## HISTORIC AND DESIGN REVIEW COMMISSION

**HDRC CASE NO:** 2021-627  
**COMMON NAME:** N Hackberry St. between Nolan and Hays  
**ZONING:** UZROW, H  
**CITY COUNCIL DIST.:** 2  
**DISTRICT:** Dignowity Hill Historic District  
**APPLICANT:** Miranda Garrison/City of San Antonio  
**OWNER:** City of San Antonio  
**TYPE OF WORK:** Pedestrian improvements  
**APPLICATION RECEIVED:** November 29, 2021  
**60-DAY REVIEW:** Not applicable due to City Council Emergency Orders  
**CASE MANAGER:** Katie Totman  
**REQUEST:**

The applicant is requesting a Certificate of Appropriateness for approval to install new sidewalks, ADA ramps, and driveway approaches and reduce the number of automobile lanes from four (4) to two (2) along N Hackberry from Hays Street to Nolan Street.

PROPOSED TYPICAL SECTION  
N HACKBERRY ST. (WITH PARALLEL PARKING)  
FROM NOLAN ST. TO HAYS ST.

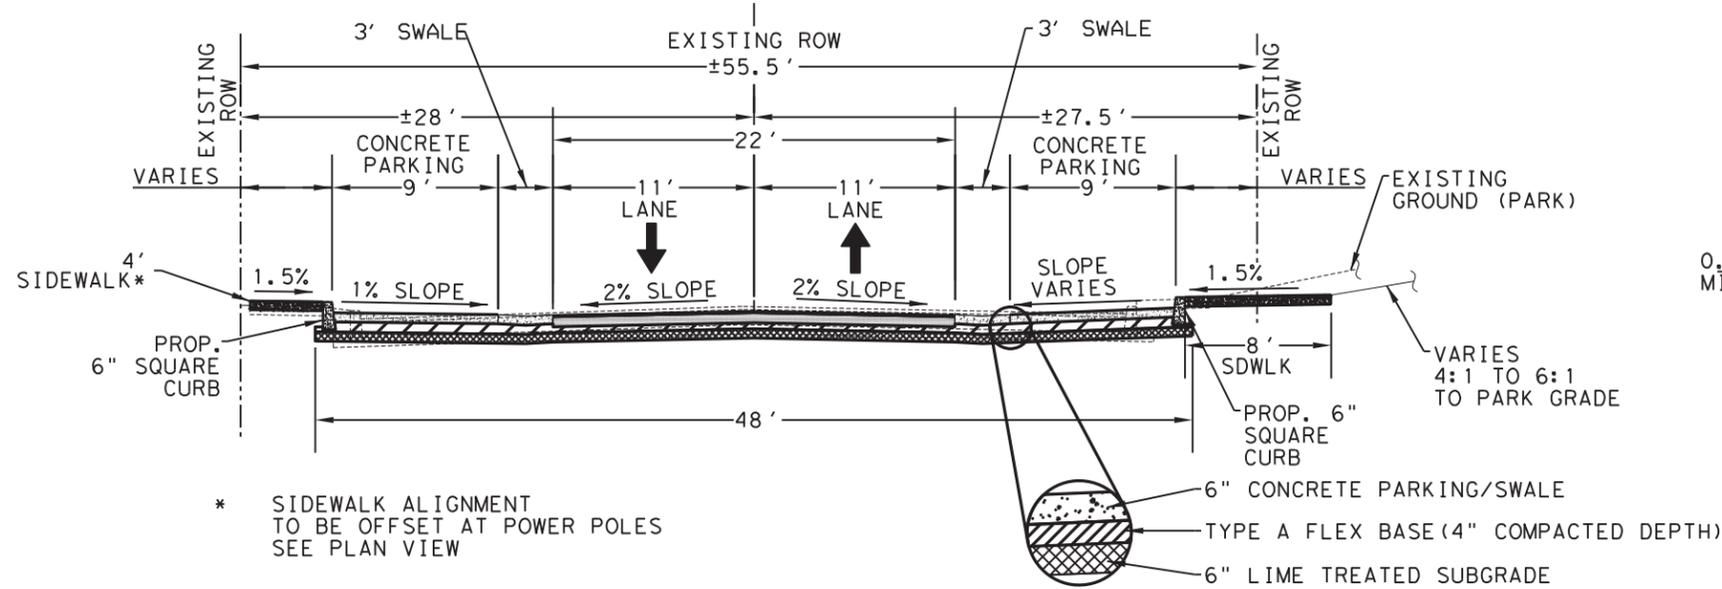
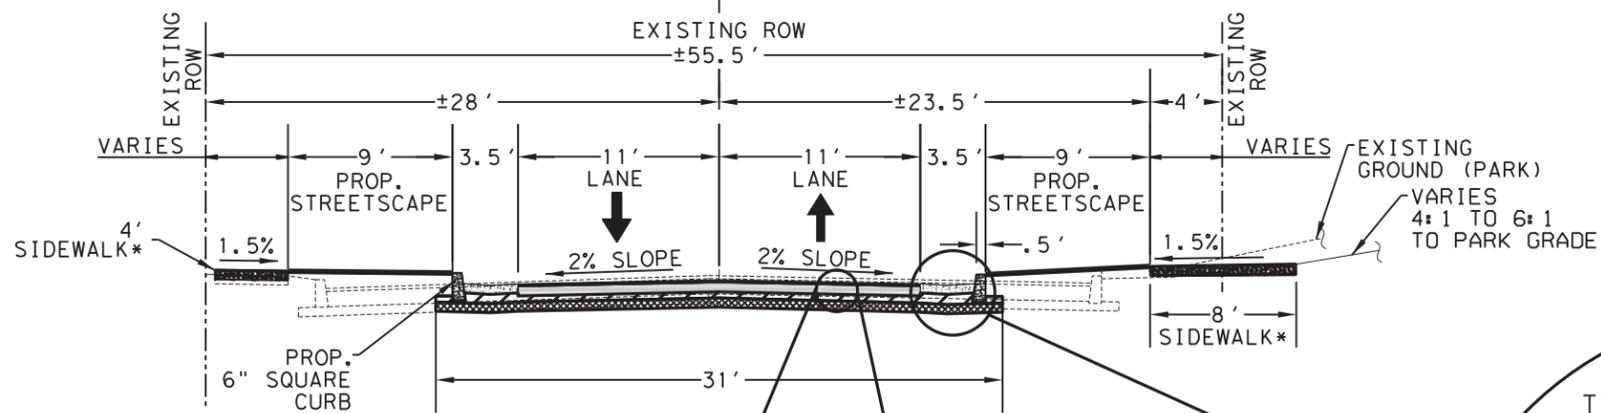
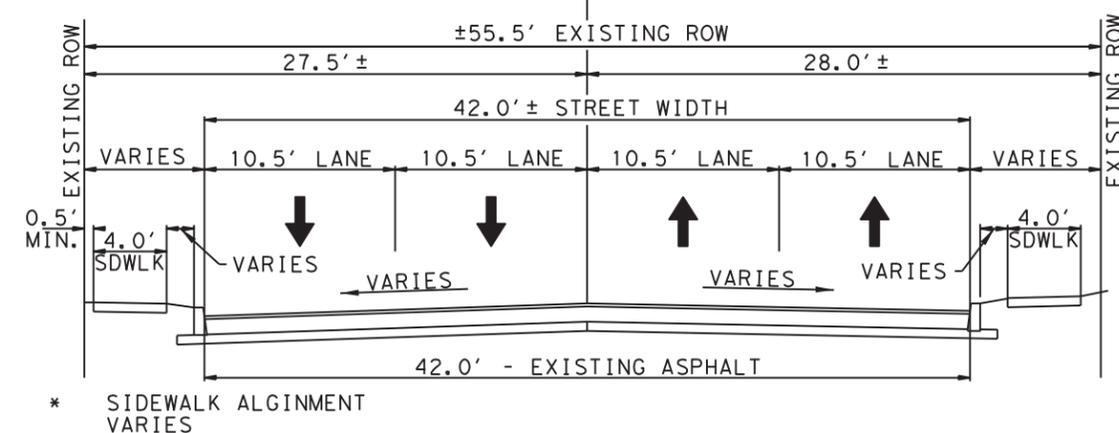
- e. LANE MODIFICATION – The applicant has proposed to reduce the number of traffic lanes along the project area, from four (4) lanes to two (2) lanes. The reduction in lanes along the project area will require a curve in the sidewalk as it approaches the street corners. Generally, staff finds that the proposed configuration of the sidewalk in these specific areas does not negatively impact the overall streetscape.

**CITY OF SAN ANTONIO**  
PUBLIC WORKS DEPARTMENT  
N HACKBERRY ST. IMPROVEMENTS  
NOLAN ST. TO HAYS ST.  
**INTERSECTION - NOLAN ST.**

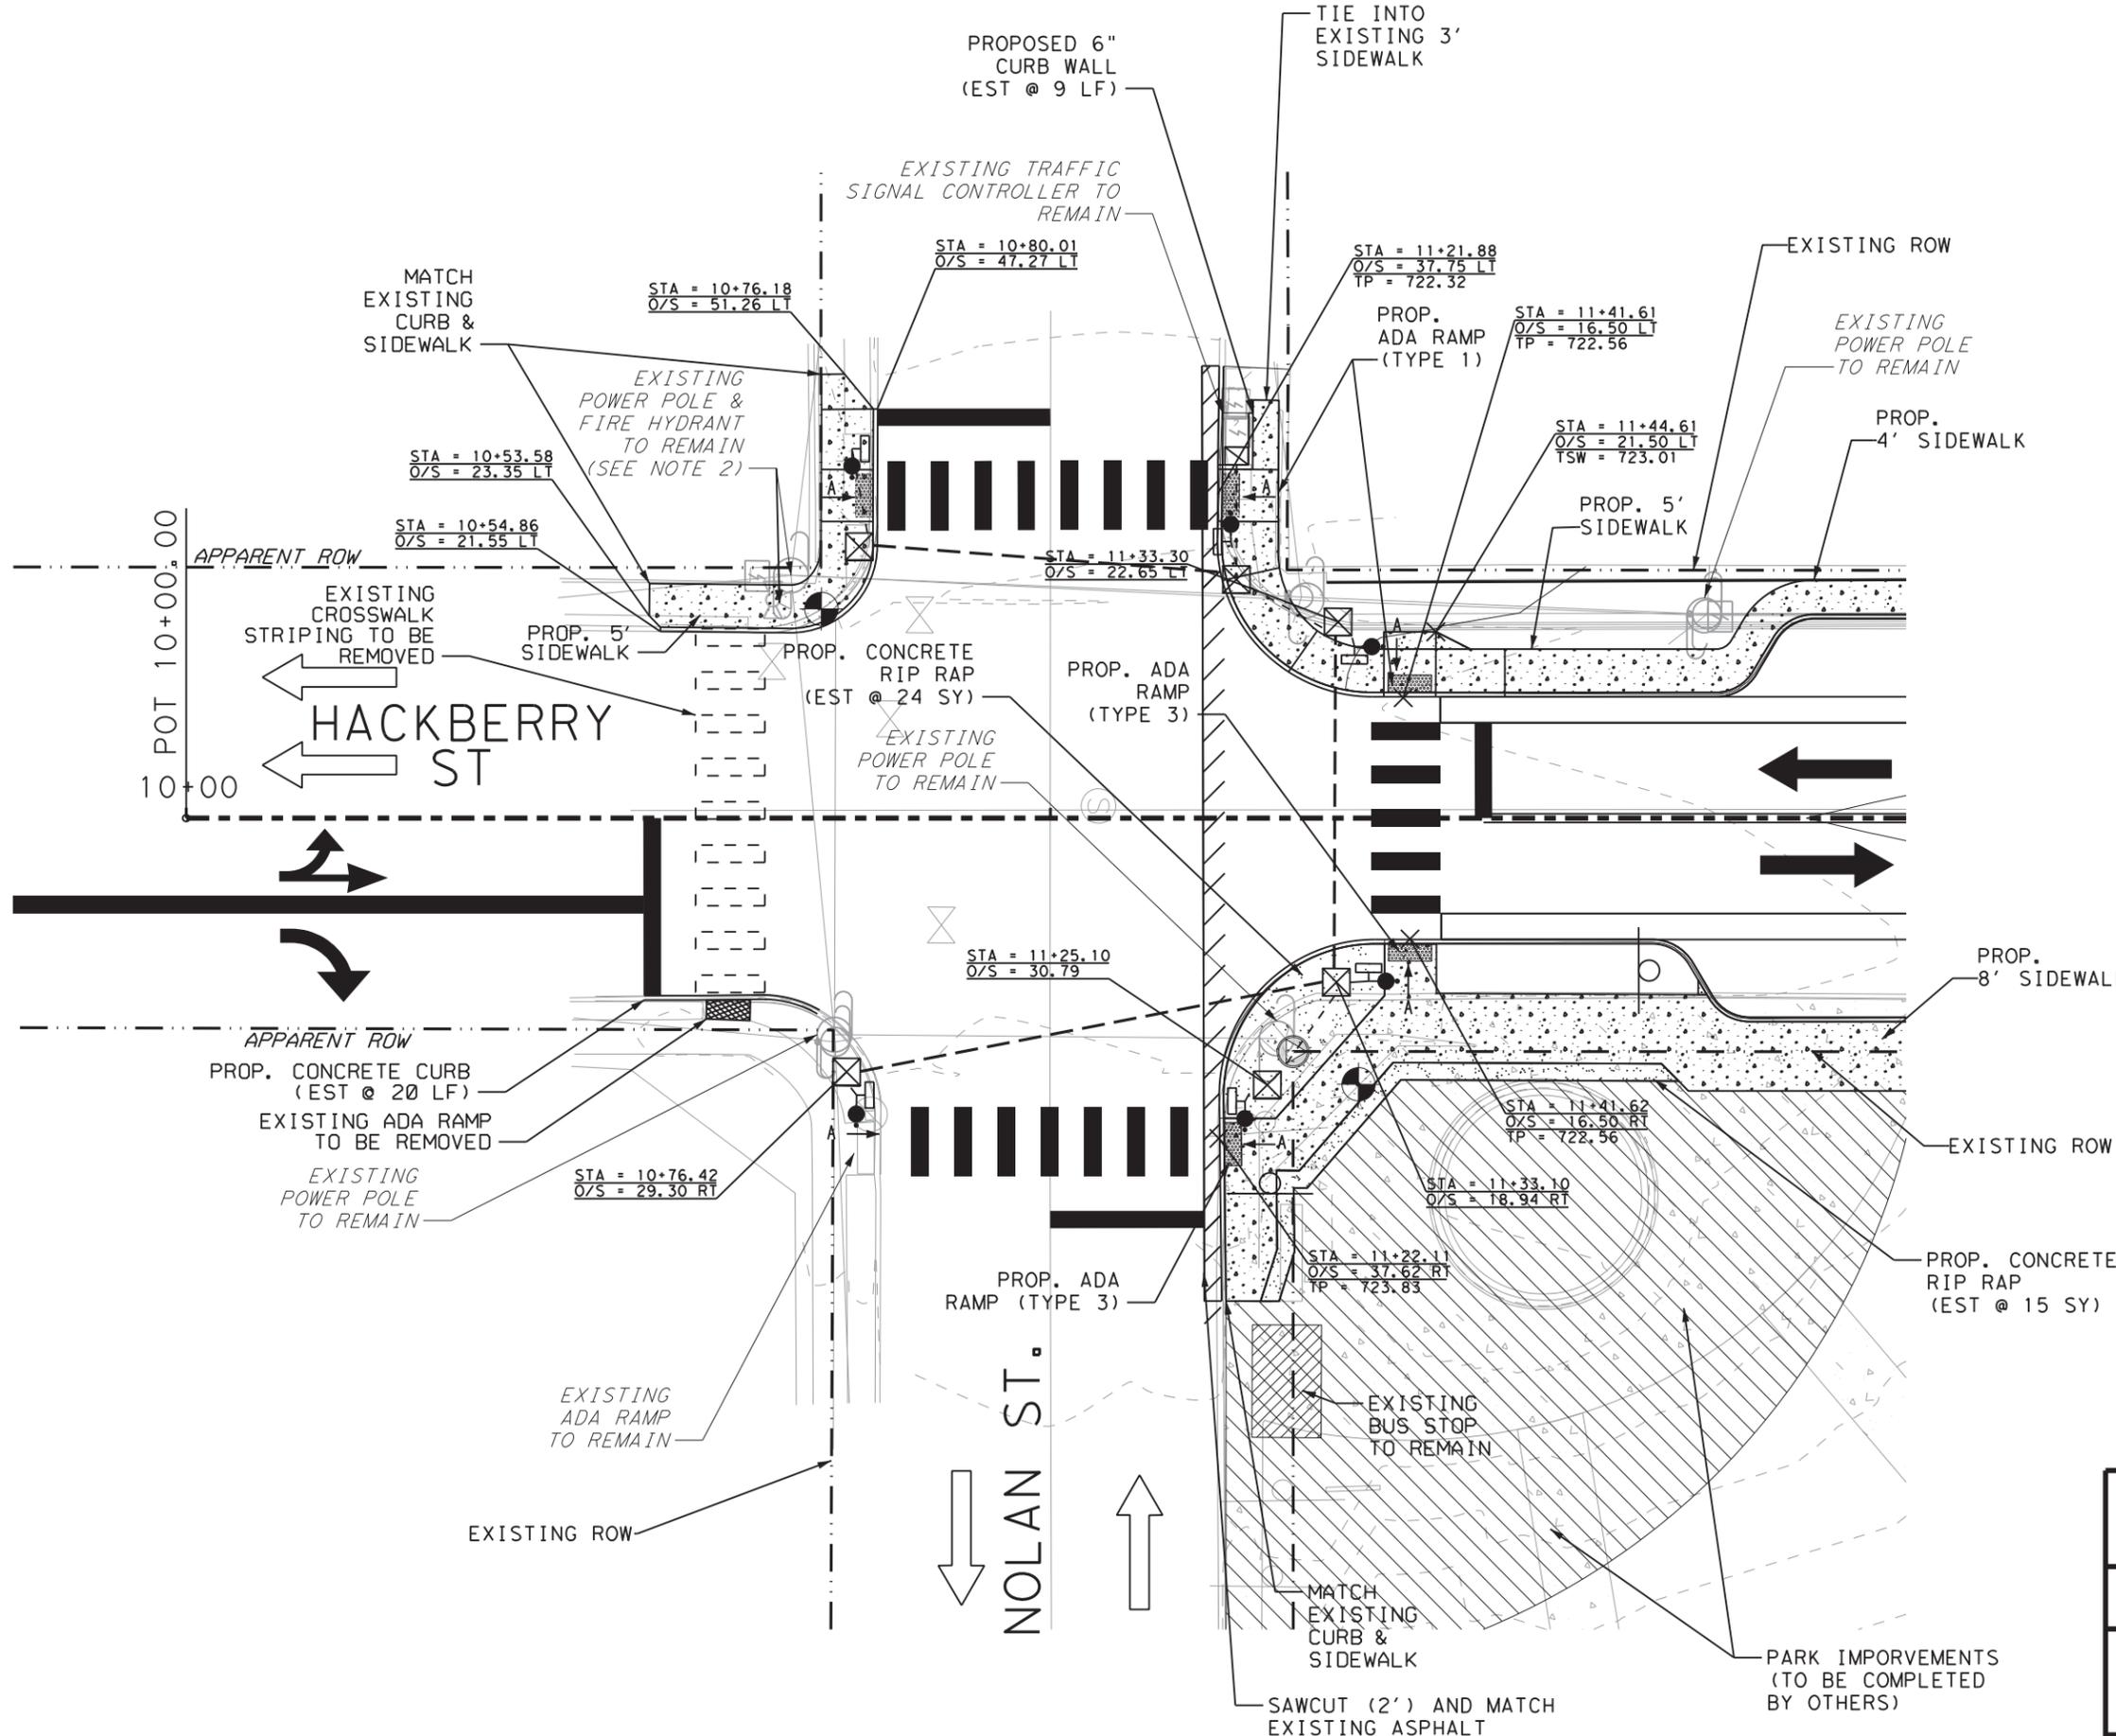
- d. ADA RAMP INSTALLATION – The applicant has proposed to install ADA ramps at the corners of Nolan, Burnet, and Hays Street. Guideline 8.C.iii for Site Elements states that new ADA curb cuts on historic sidewalks should be installed to be consistent with the existing sidewalk color and texture while minimizing damage to the historic sidewalk. Staff finds that the installation of new truncated dome panels should match existing truncated dome pads in the district.

- i. That the historic curbing is retained and any curbing that requires replacement matches the existing in material, width, and profile.
- ii. That the applicant maintains the width of existing driveway approaches and walkways. Any modifications to the footprint of the existing driveway approaches and walkways will require additional review and approval by staff.
- iii. That the applicant installs truncated dome panels to match the existing truncated dome panels in the district.
- iv. The project shall comply with all federal, state, and local laws, and regulations regarding archaeology, as applicable.
